STATE OF DELAWARE
DEPARTMENT OF TRANSPORTATION
800 BAY ROAD
P.O. BOX 778
DOVER, DELAWARE 19903

February 17, 2009

DelDOT Contract Number: 95-090-01; Federal Aid Project Number: IM-N056(27)
I-95 Delaware Turnpike Improvements Project
I-95/SR 1 Interchange/I-95 Turnpike Mainline
Turnpike Mainline from SR 1 to SR 141; I-95/SR 1 Interchange; I-95 Northbound
Widening Extension
New Castle County, Delaware
Environmental Reevaluation [*Change in interchange design*]

January 2009

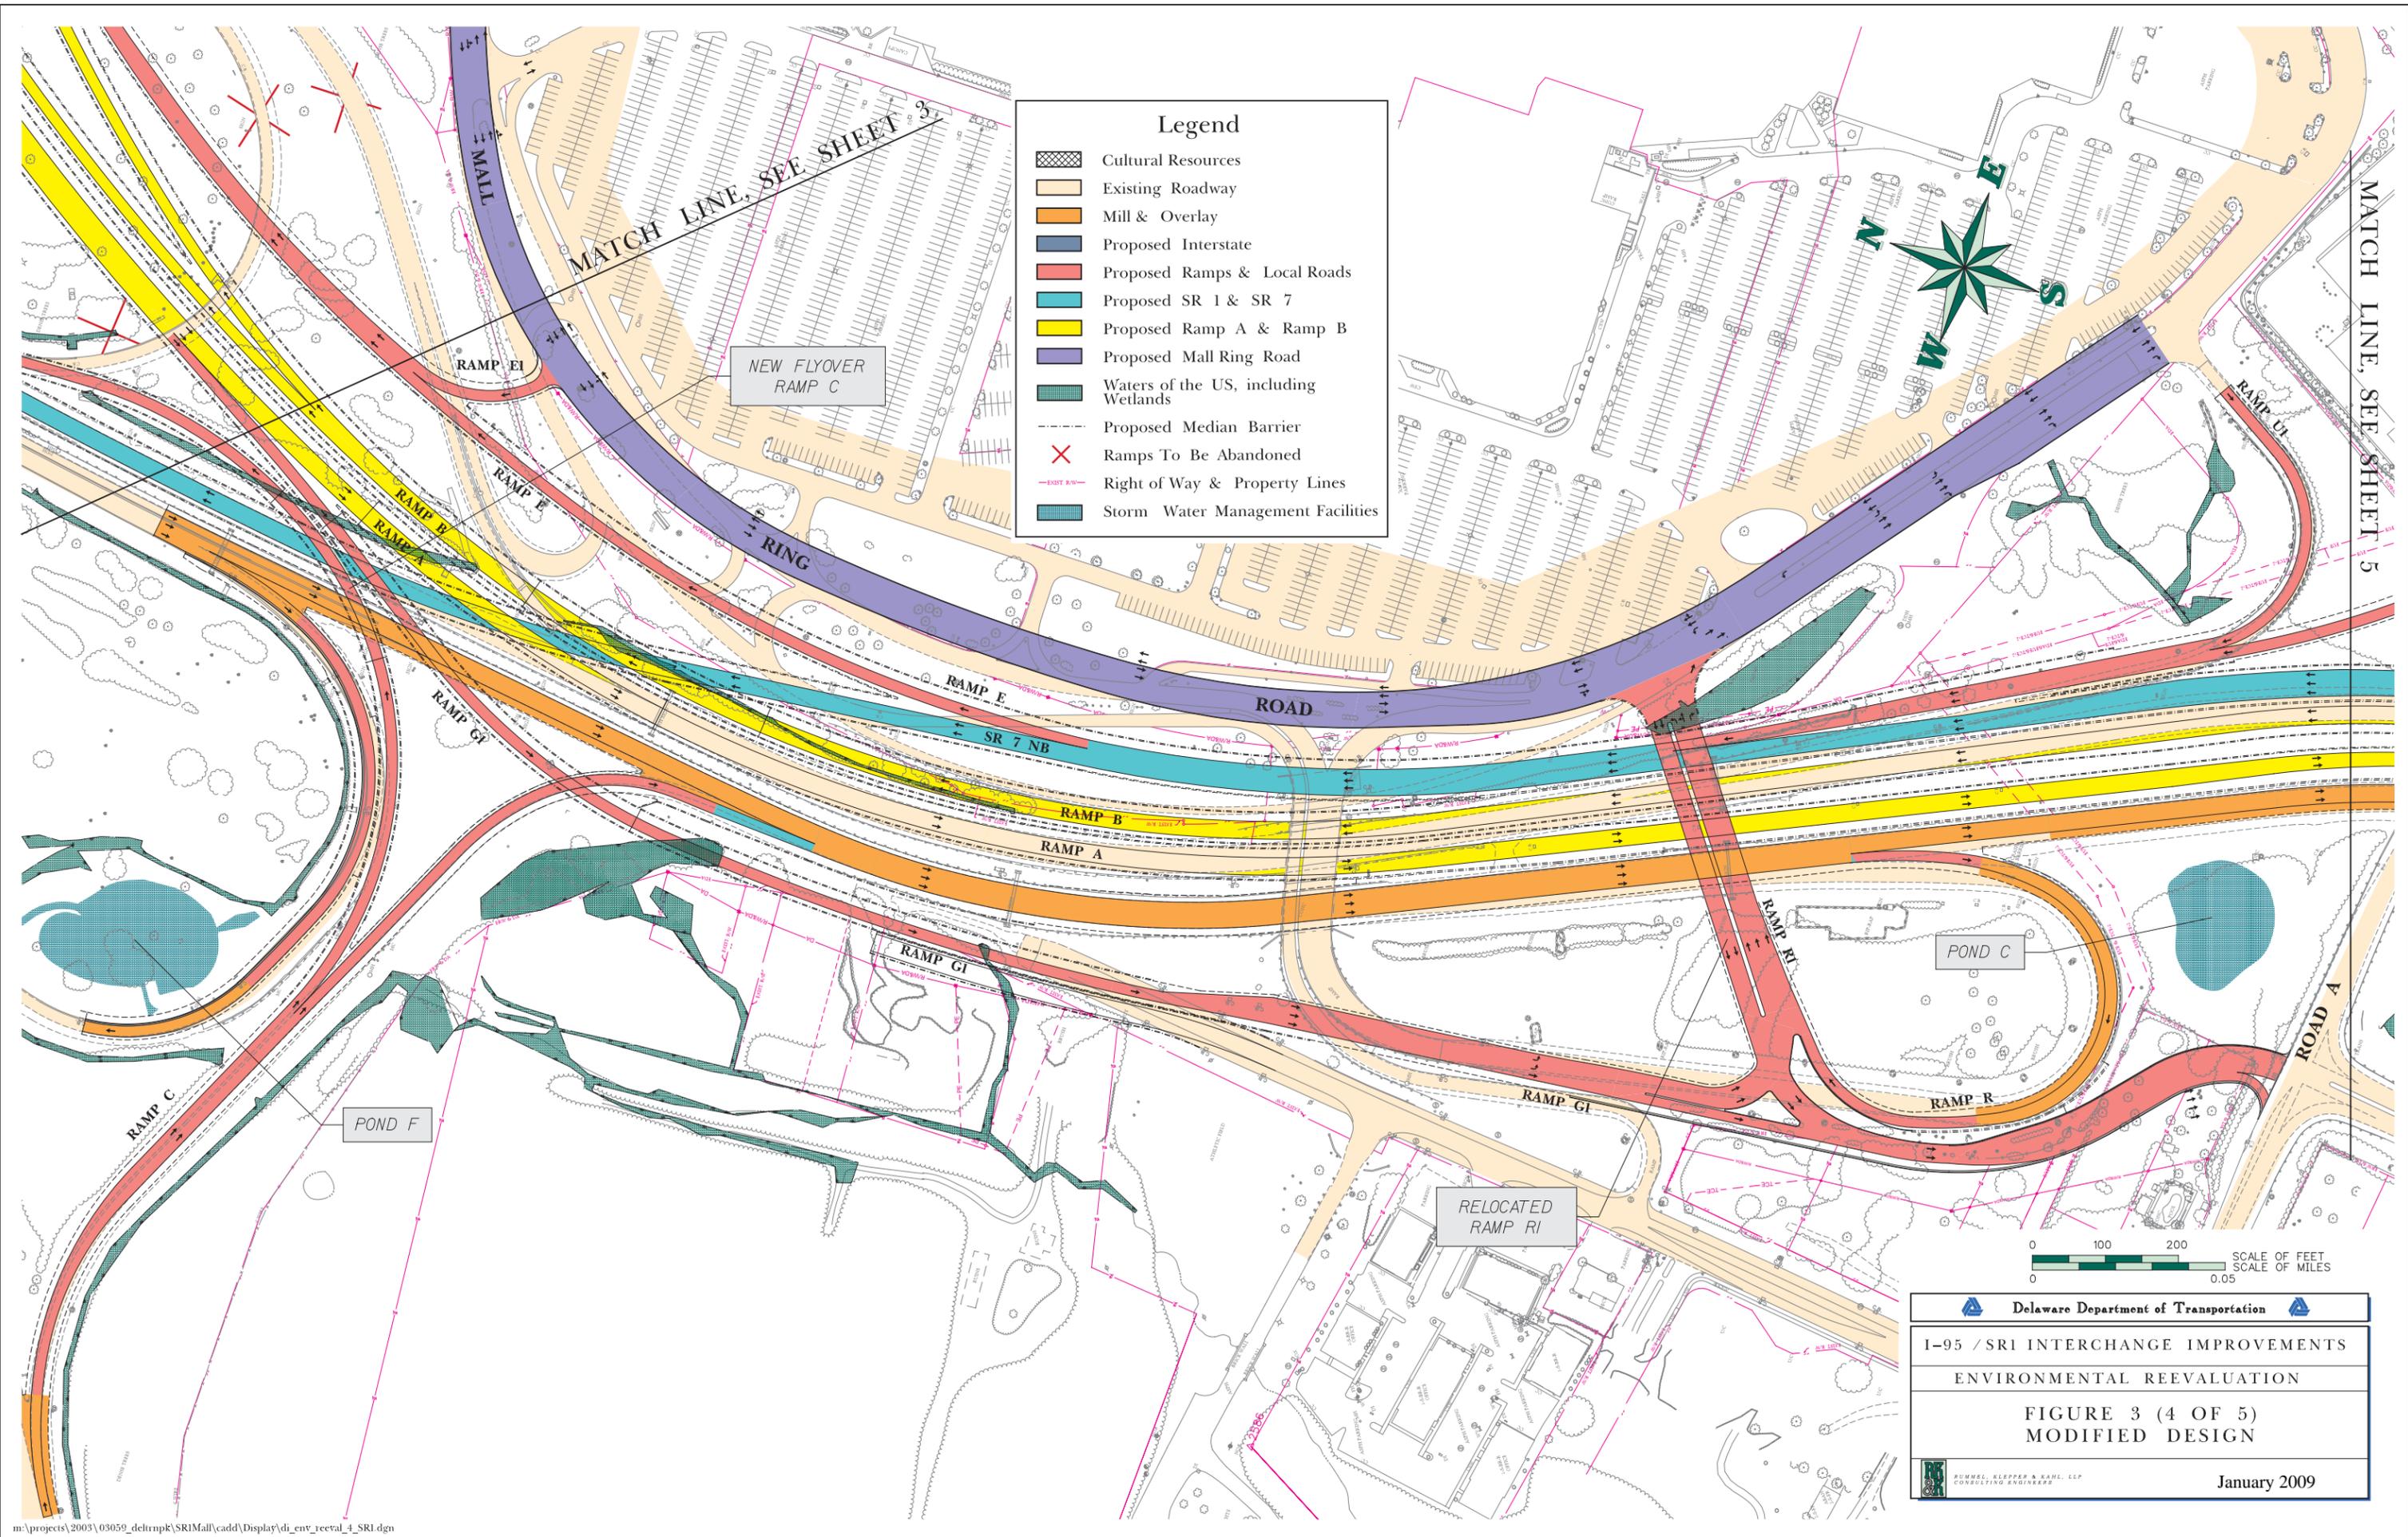
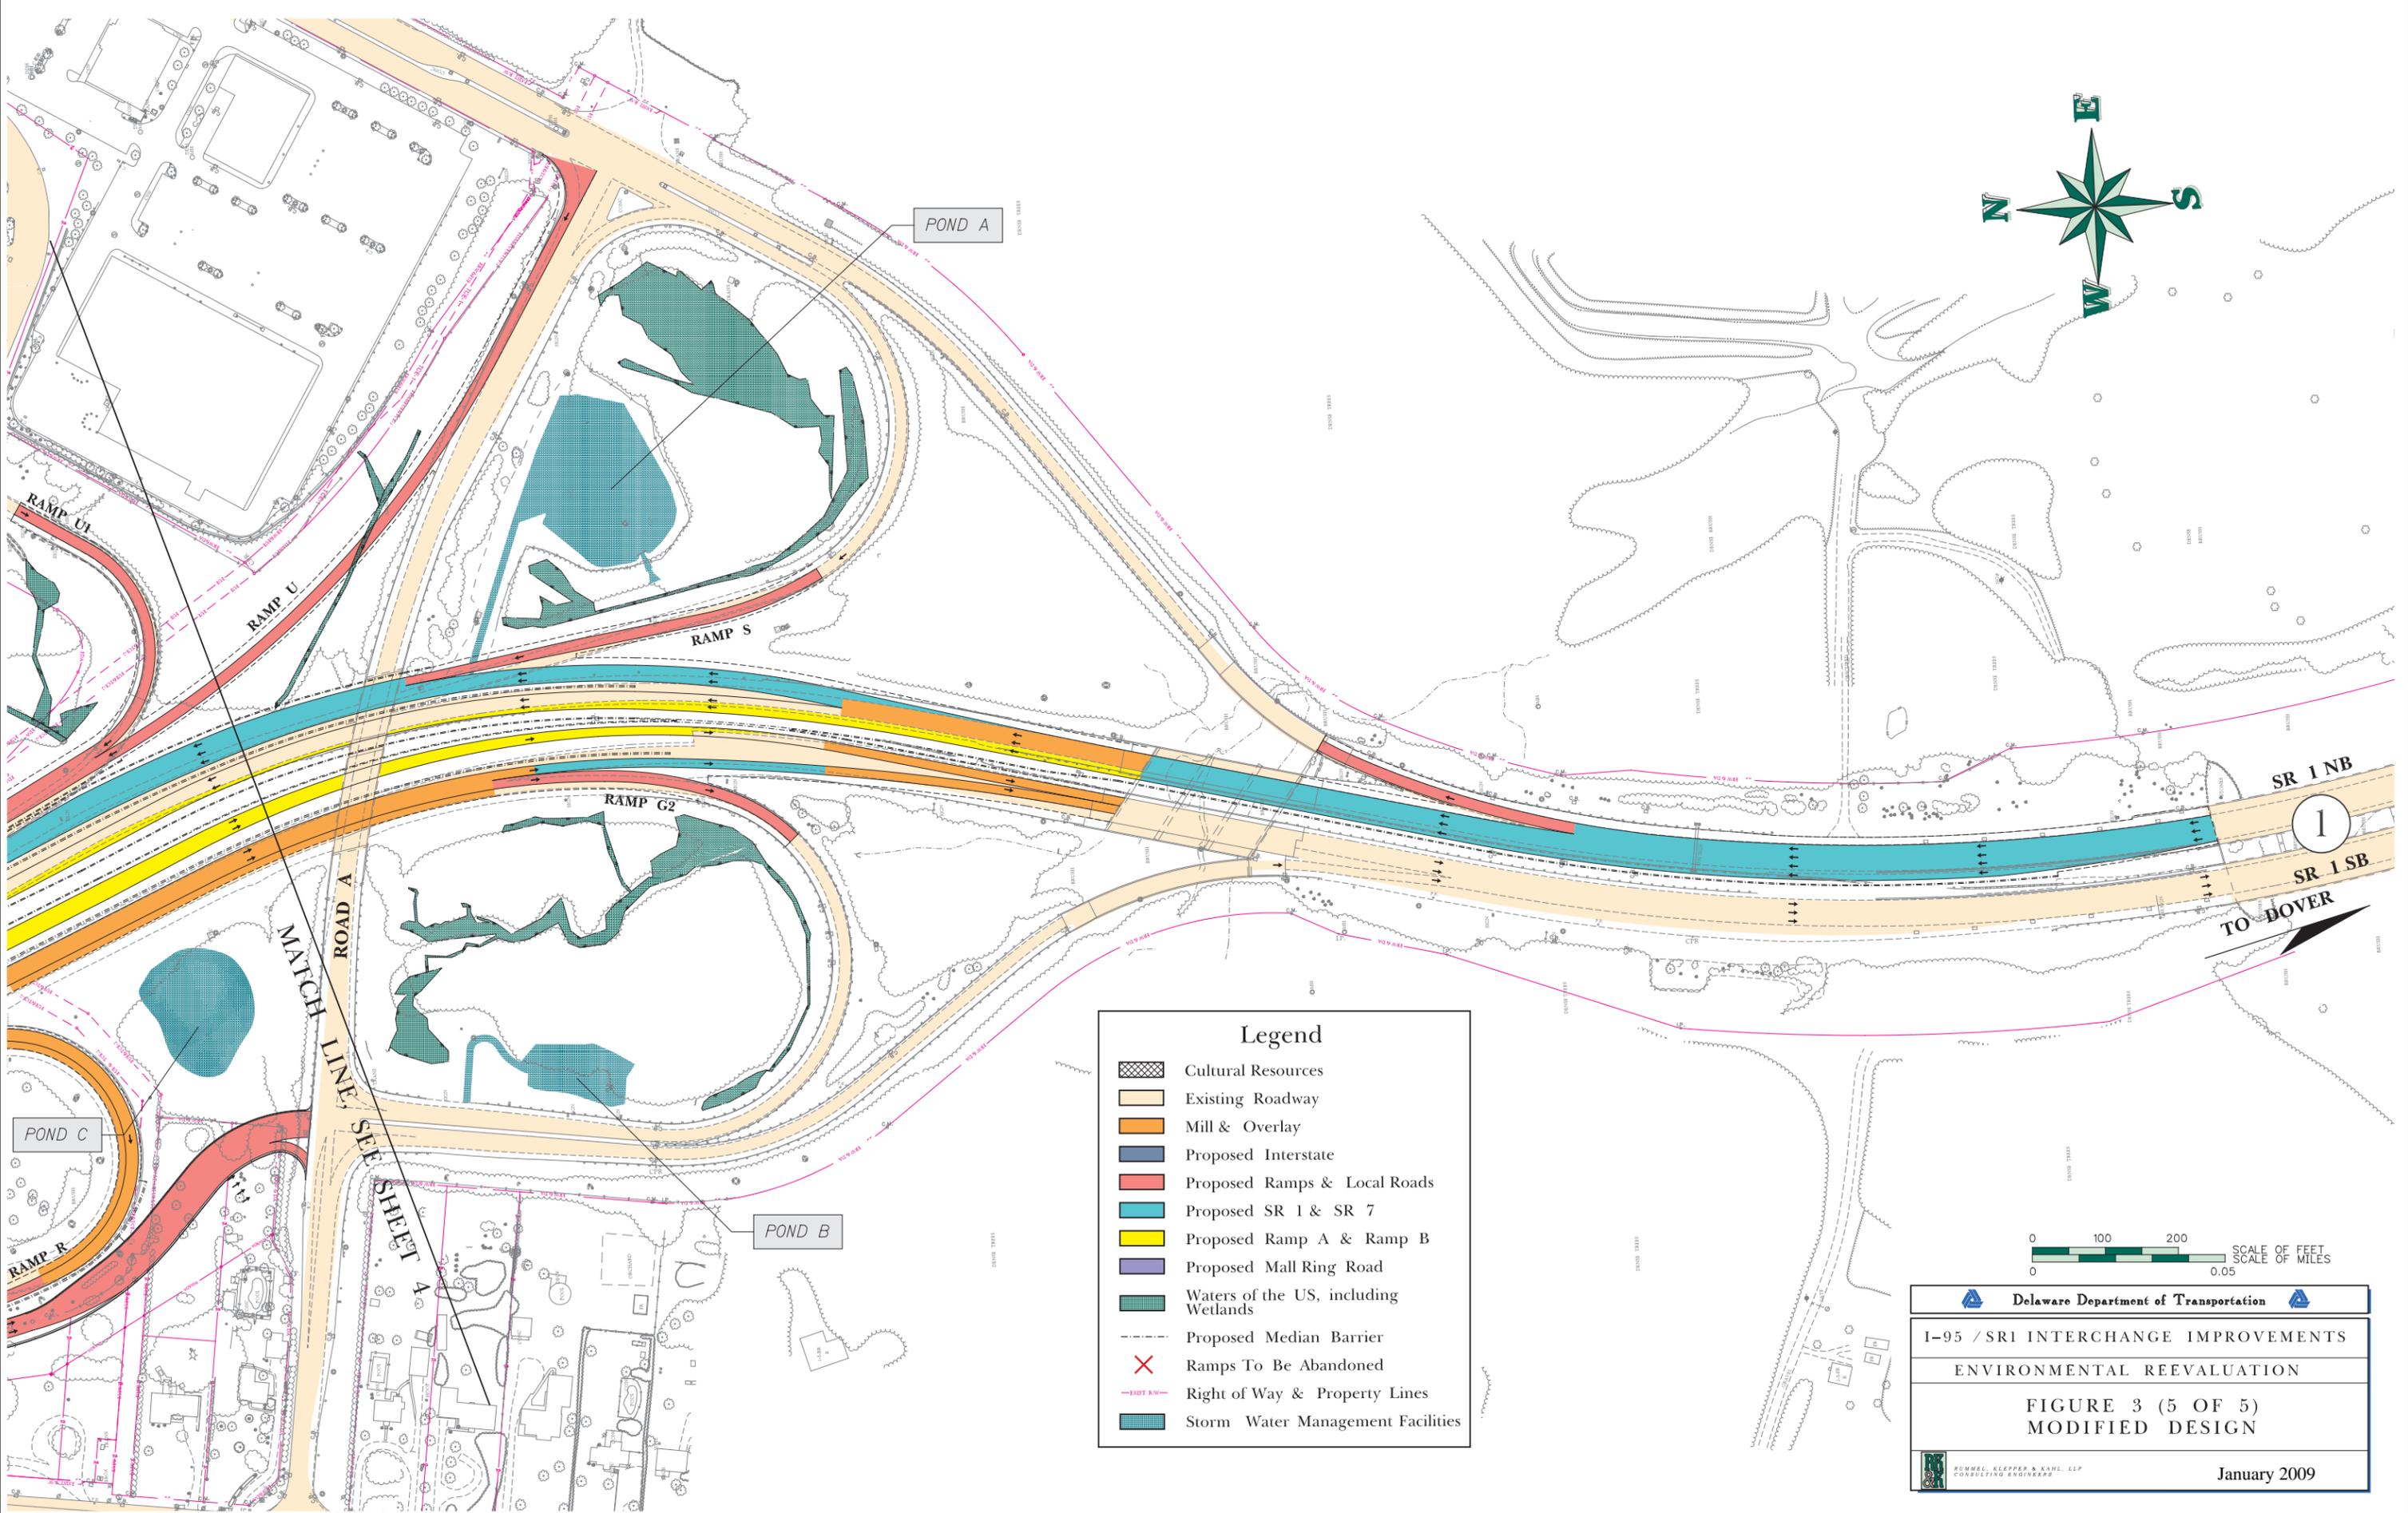
- The existing southeast quadrant loop ramp (from I-95 northbound to SR 7 northbound) has been eliminated and replaced by a semi-directional flyover ramp (identified on **Figure 3** as Ramp C) that extends from the southwest outer ramp from northbound I-95, passes over SR 7 and merges with northbound SR 7.

- The existing northbound lanes of I-95, north of the interchange, are shifted approximately 40 feet to the outside to accommodate Ramp B, which will fly over northbound I-95 and extend as the median lane of I-95.
- Ramp B (SR 1 northbound to I-95 northbound) will split in the vicinity of the southwest quadrant. The left lane will fly over northbound I-95, and become the median lane of the northbound I-95 mainline, as noted above. The right lane of Ramp B (Ramp B1) will extend along the outside of existing northbound I-95 and remain barrier-separated from the northbound I-95 mainline until north of the Churchmans Road bridge, where the lane merges with the existing outside mainline lane.
- The ramp (Ramp R1) to/from the Christiana Mall Road will be relocated approximately 150 feet south of its present location.

- The replacement of the southeast quadrant loop ramp with the directional flyover ramp from I-95 northbound to SR 7 northbound will eliminate the existing weave on northbound I-95, between the entry loop ramp to northbound I-95 from southbound SR 7 and the exit loop ramp from northbound I-95 to northbound SR 7.

- Shifting the I-95 mainline to the outside and bringing the split Ramp B (SR 1 northbound to I-95 northbound) into I-95 as the median lane of I-95 allows motorists from SR 1 destined for Wilmington to avoid having to weave across four lanes of I-95 within a distance of approximately four miles.

- The relocation of the Ramp R1 bridge approximately 150 feet to the south will allow for a lower profile for the ramp bridge and the reconstructed Christiana Mall Road, thus reducing the impact to the mall parking lot and eliminating a proposed retaining wall. Shoulder reductions in some areas have been reduced from 16/24 feet to 12 feet to accommodate the changes and avoid additional property acquisition from the Mall.

See **Figure 3** for locations of Ponds A-F.
